MULLIGANS FLAT WOODLAND SANCTUARY

THROSBY RESIDENTIAL ESTATE ESTATE DEVELOPMENT PLAN

From: [REDACTED]
To: [Quayle, Stacey](#)
Cc: [REDACTED]
Subject: Throsby - response to comments provided
Date: Tuesday, 9 September 2014 4:51:32 PM
Attachments: [image001.png](#)
[image002.jpg](#)
[image003.png](#)
[Throsby LDA comments Draft EDP.docx](#)

PLAN No. 7.1

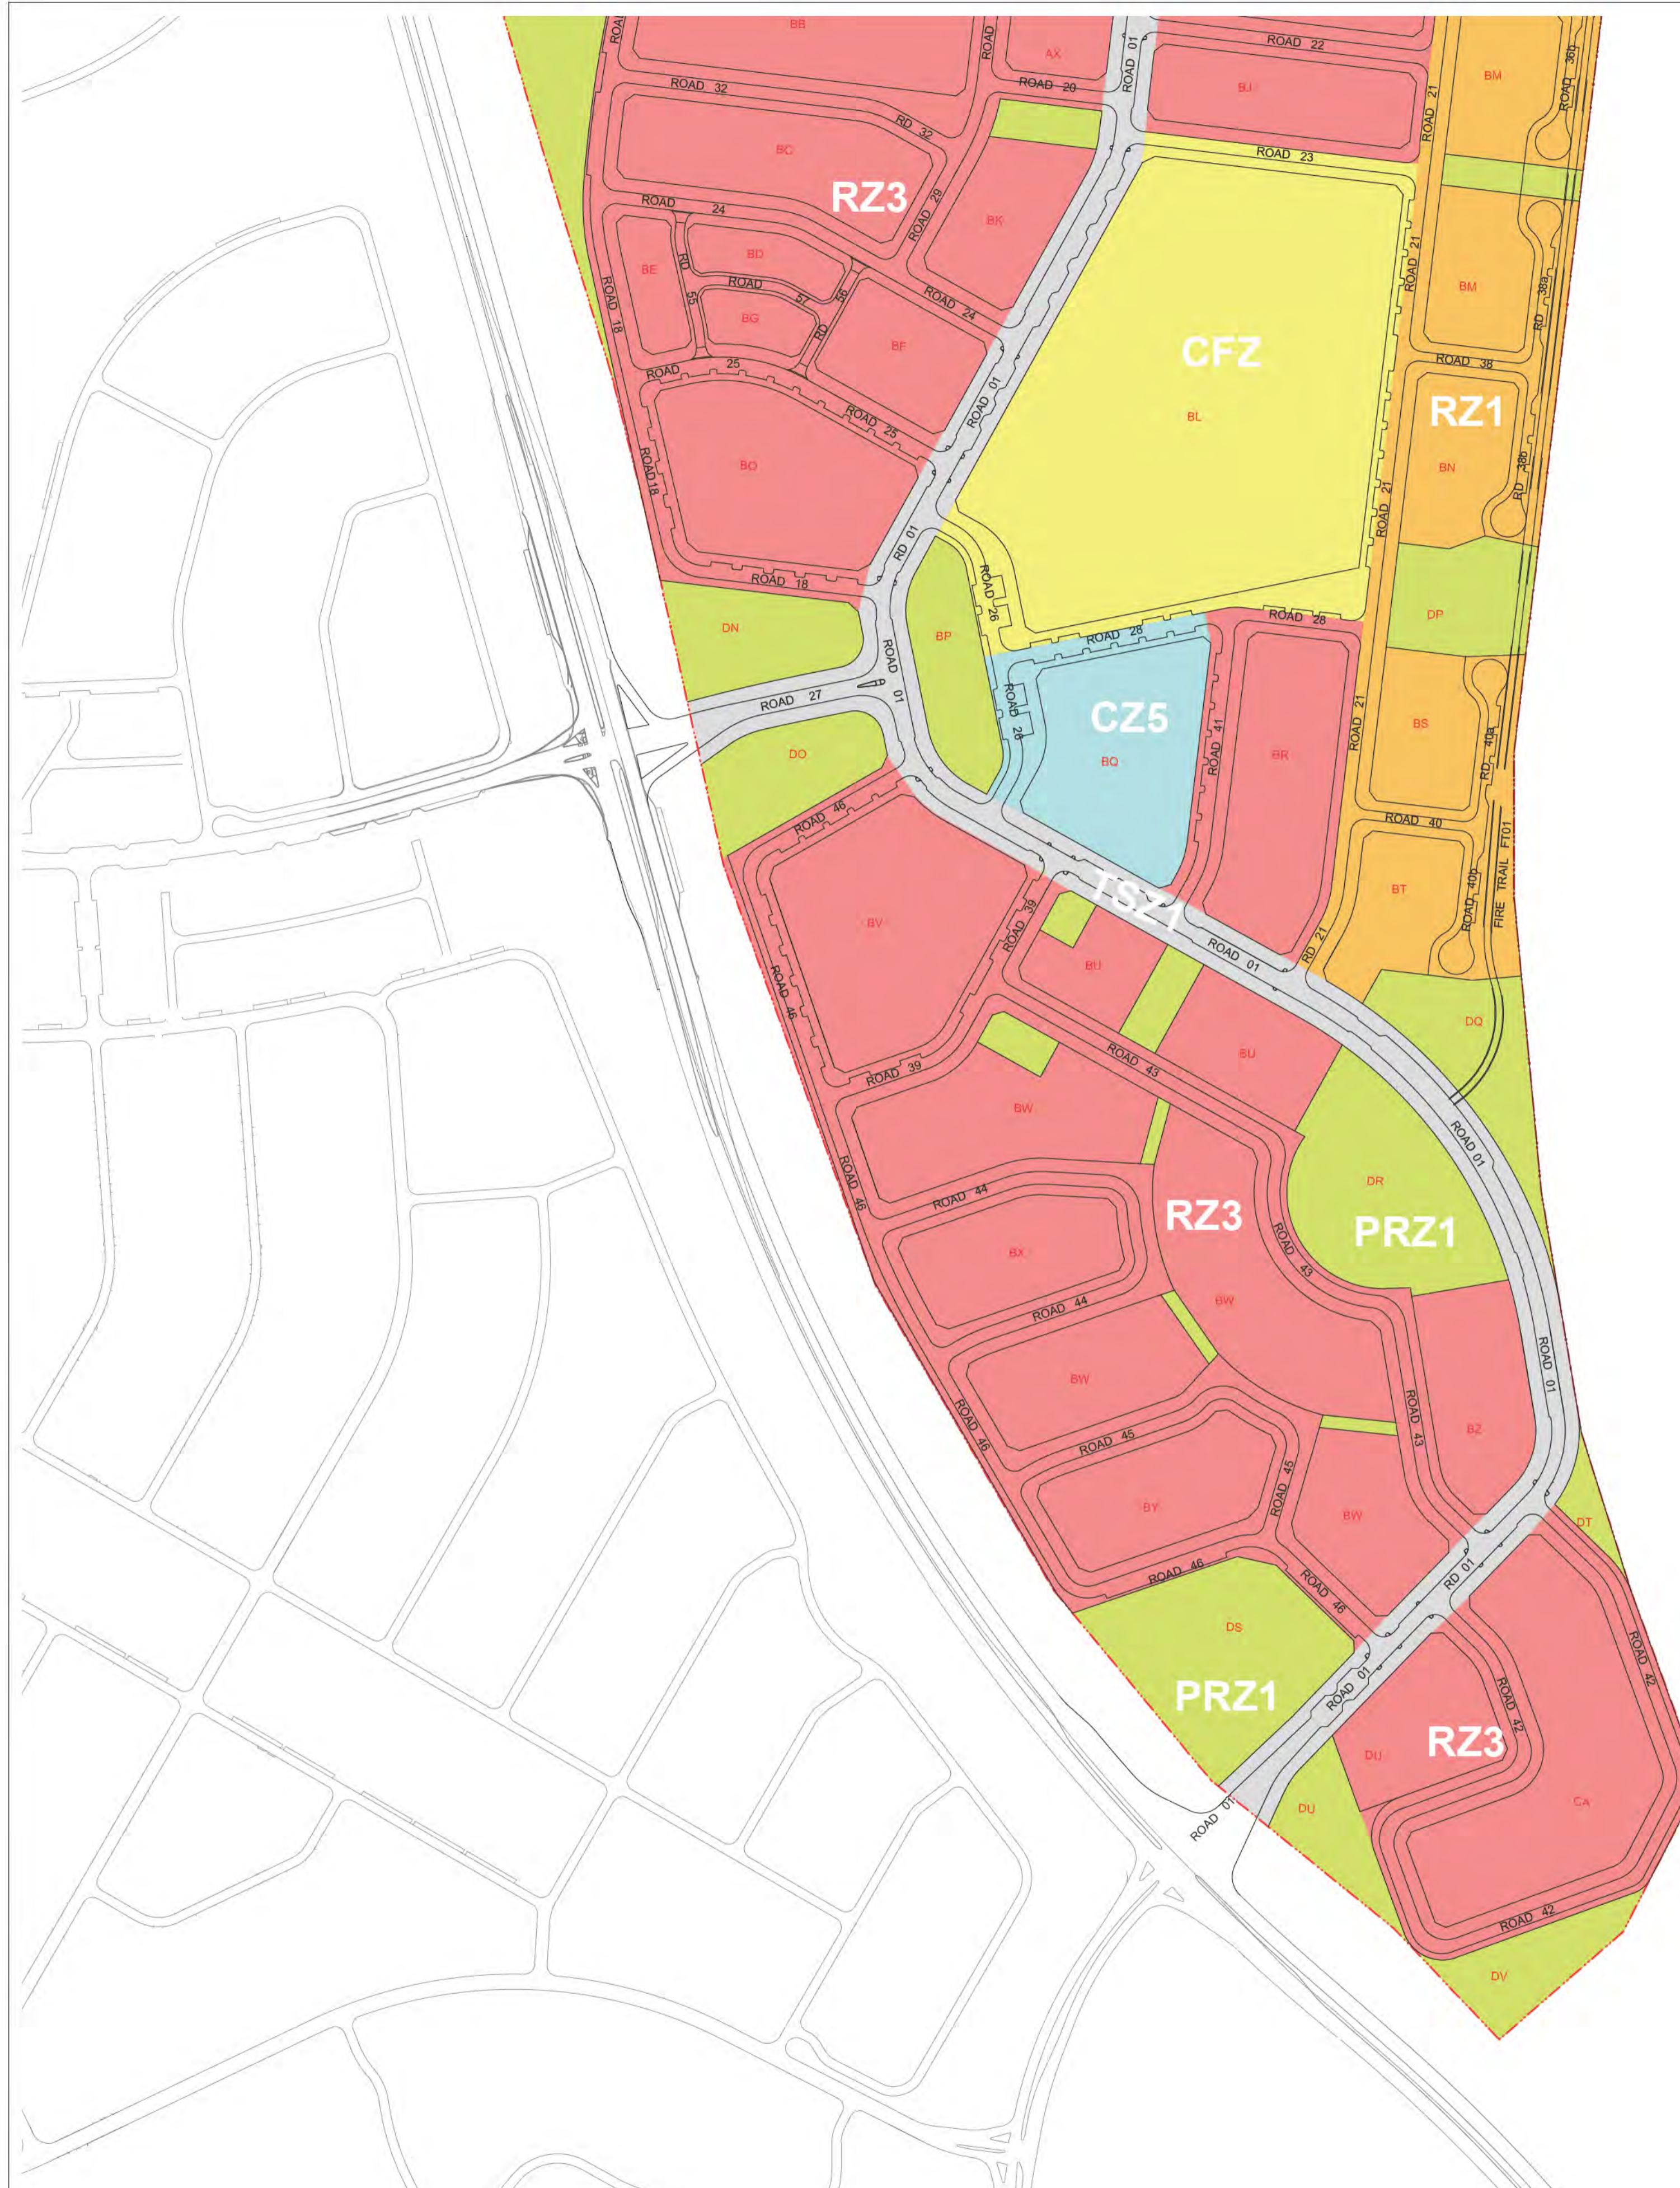
Land Use Plan:

I believe that our approach is supportable and propose to proceed as planned, but can you please advise if you would like us to zone all single dwelling residential RZ1?

Please use the zone names and colours/tones that correspond with the Territory Plan.

Please use the zone names and colours/tones that correspond with the Territory Plan.

Drawing to be updated
